# ADDENDUM No. 1

## ITB No. 4525

### CREST BUENA VISTA WASHINGTON WATER MAIN PROJECT

DRAWING No. **2016029-35**

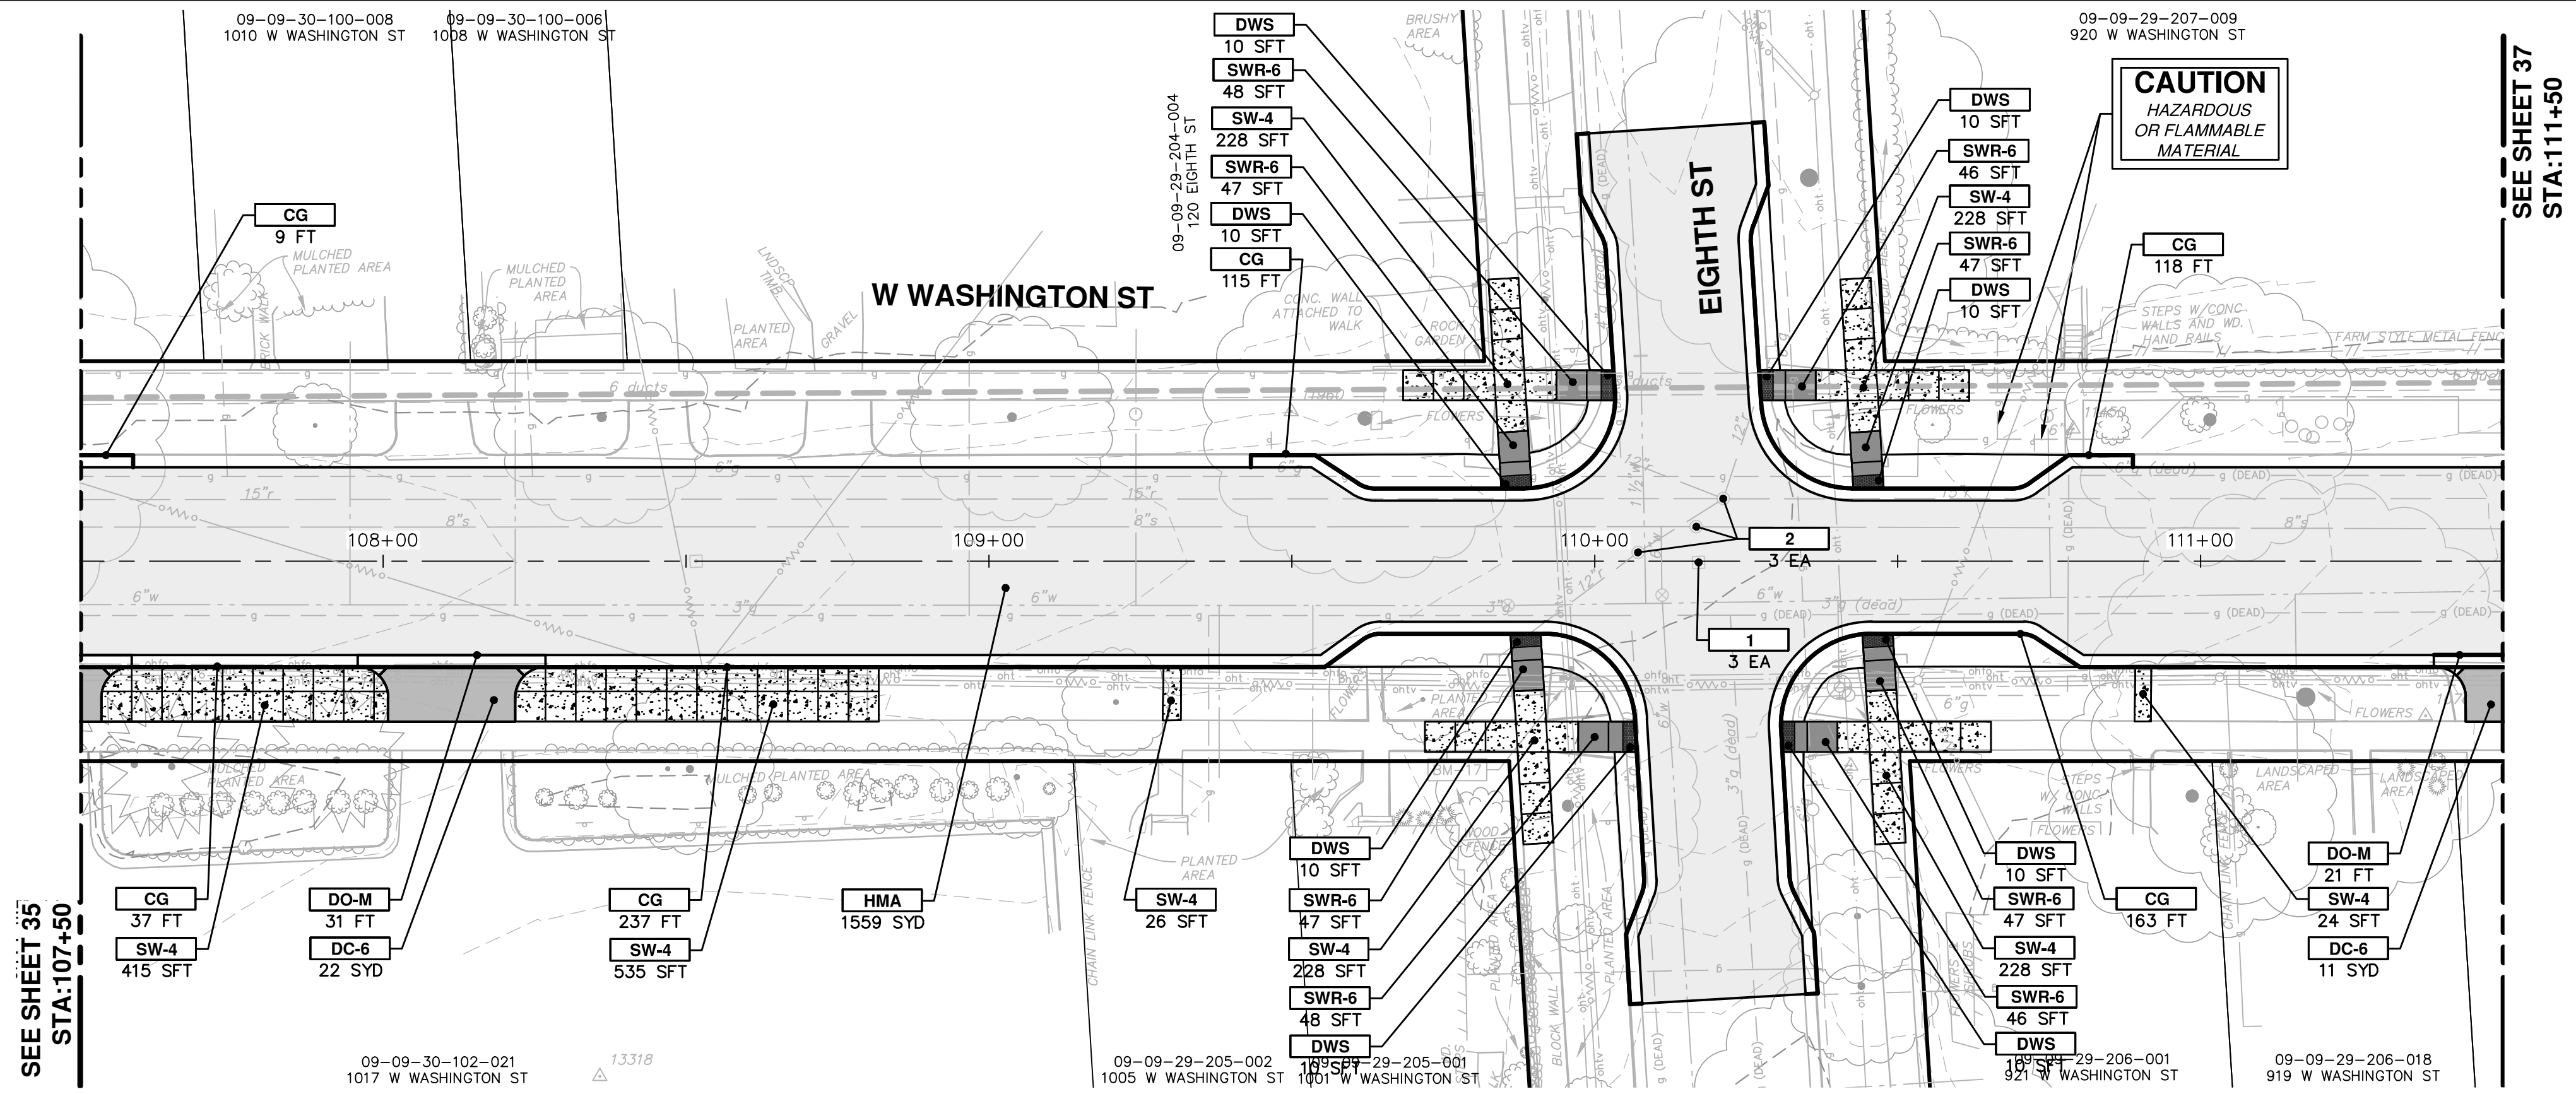
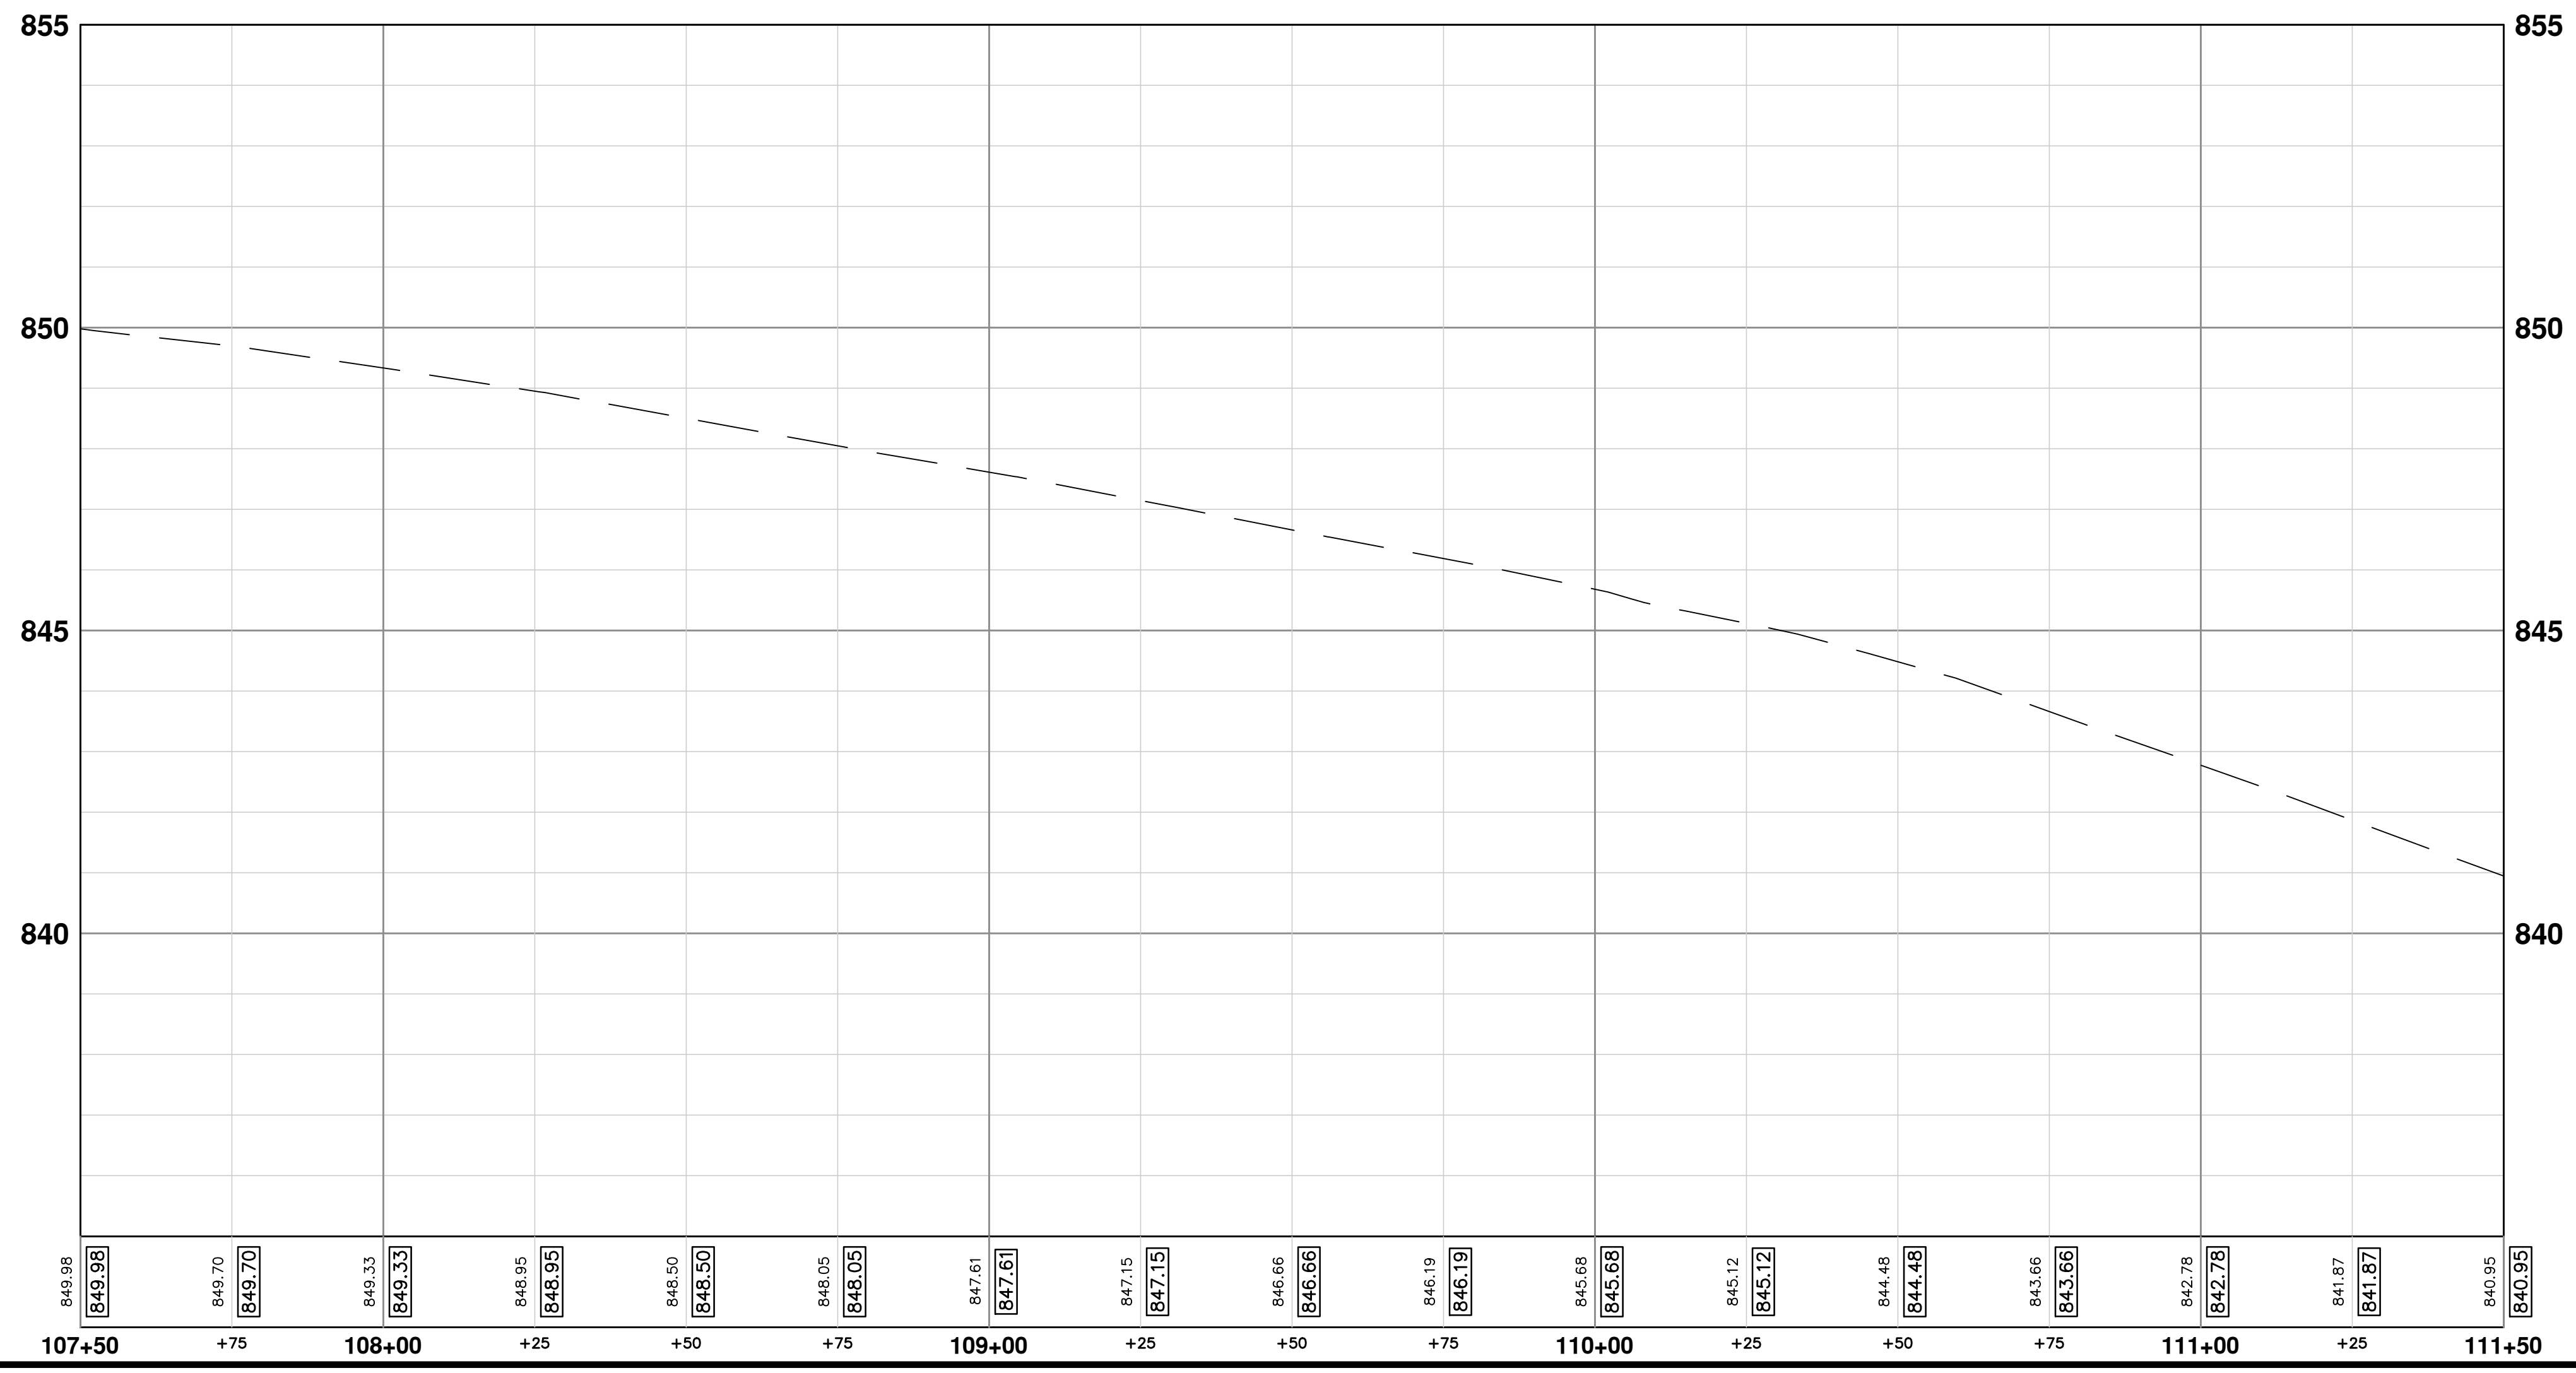
On plan sheets 34 and 35, proposed storm features were added and multiple proposed driveways, M-openings, and curb & gutter were eliminated from Washington station 0+00 to 10+00.

SHEET No. **38 OF 46**

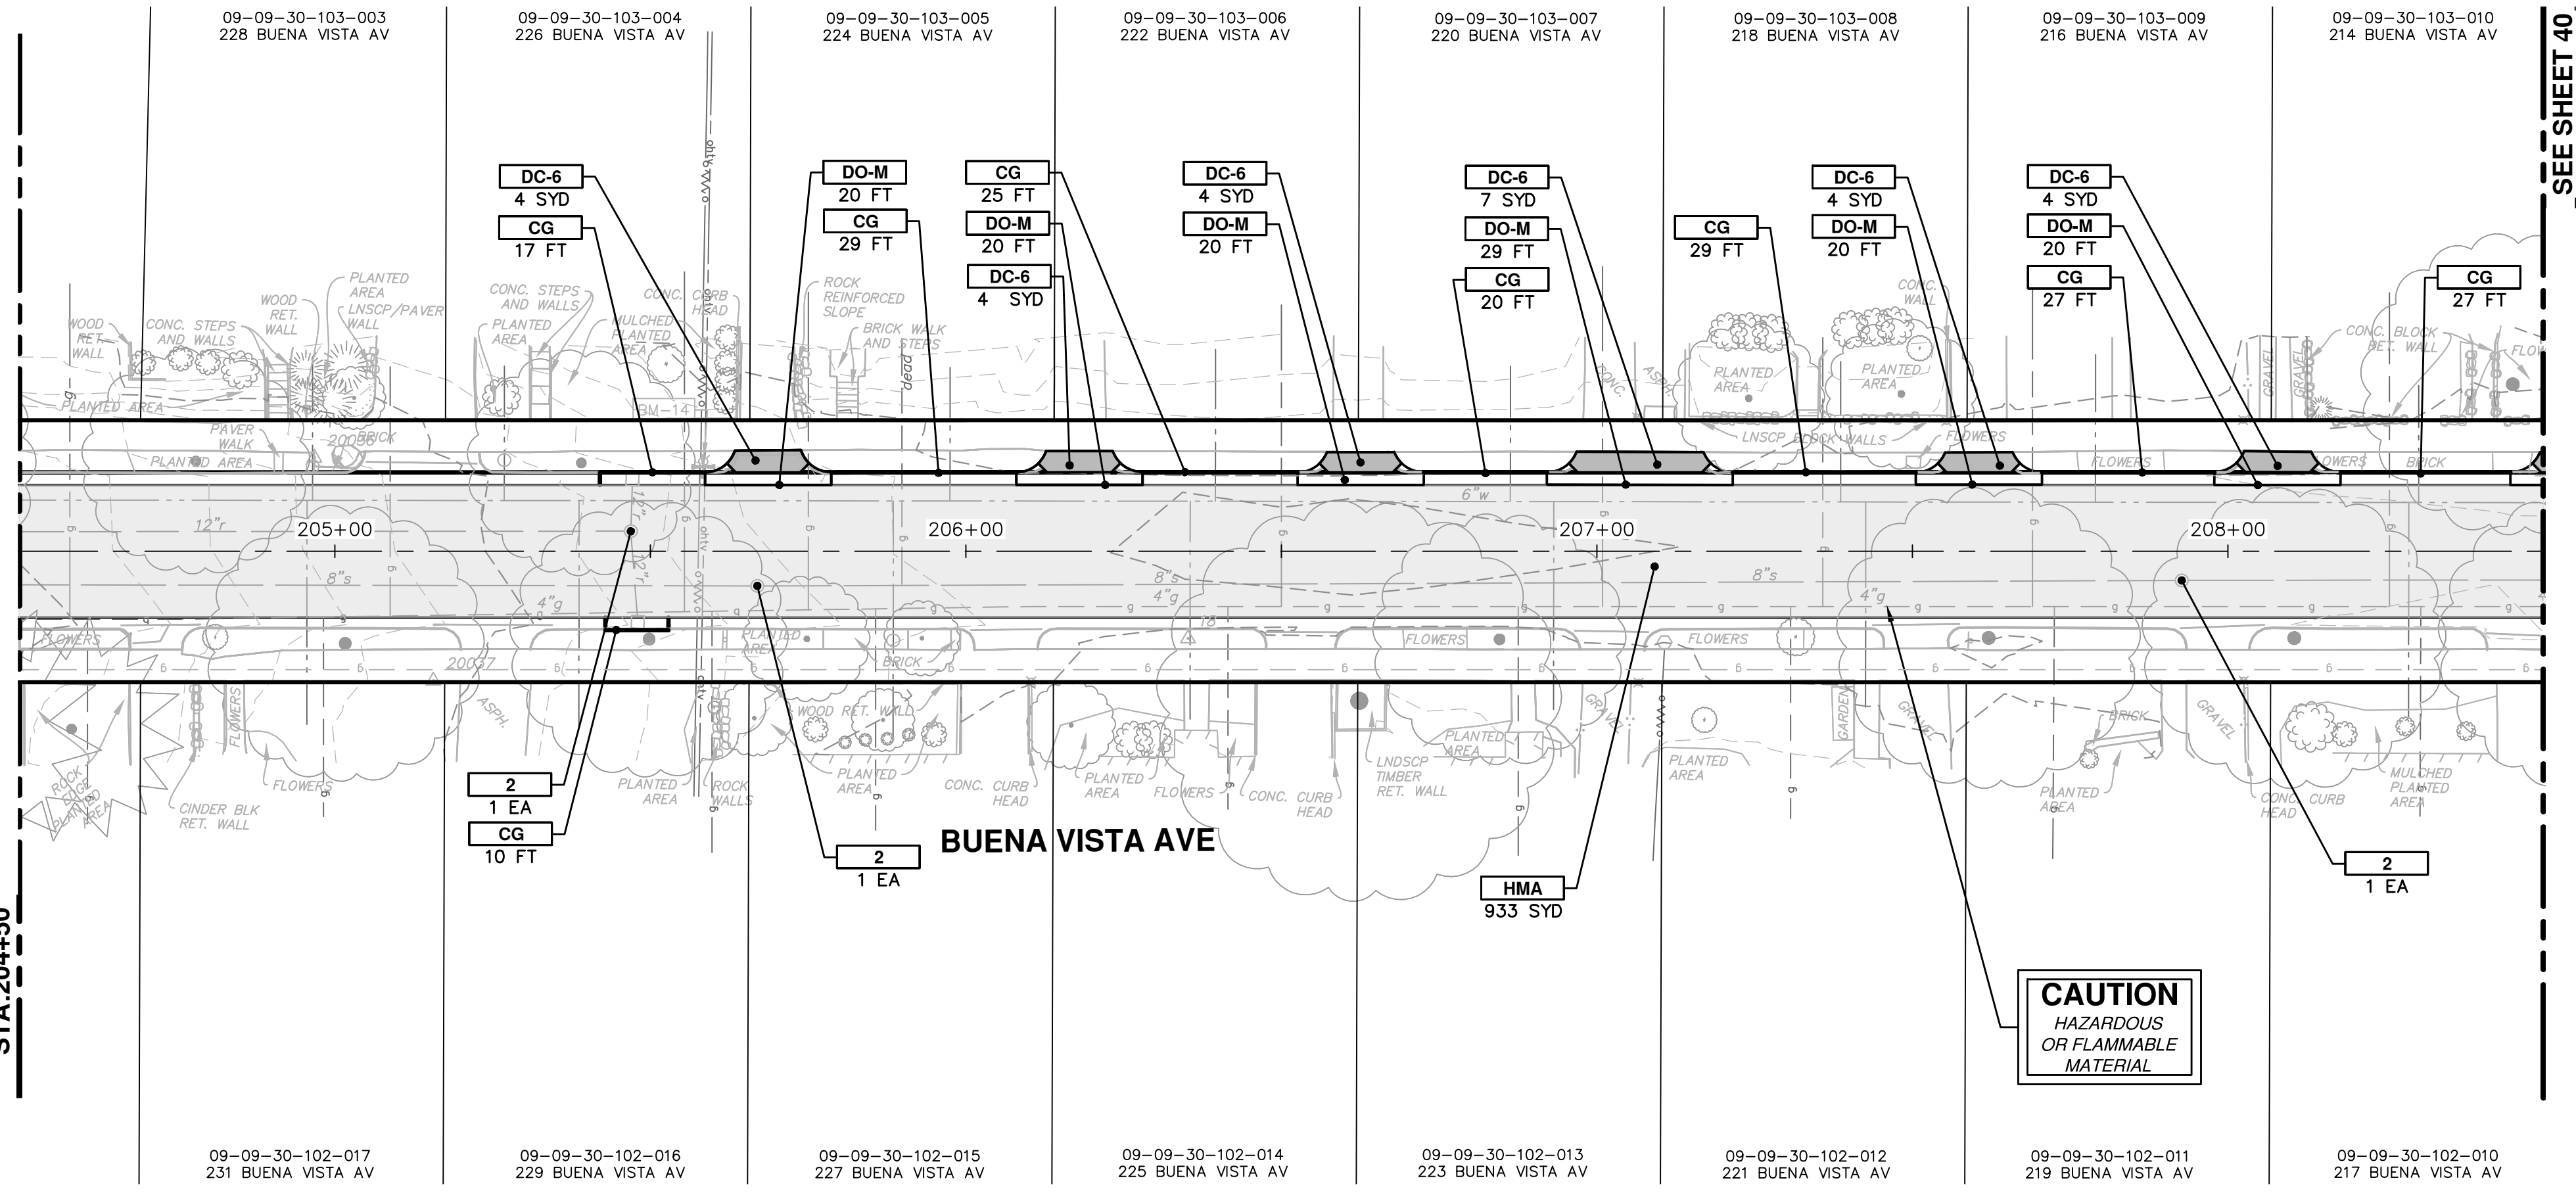
On plan sheet 38, structure and gate box adjustments were added and the sidewalk in the corner of Buena Vista was added.
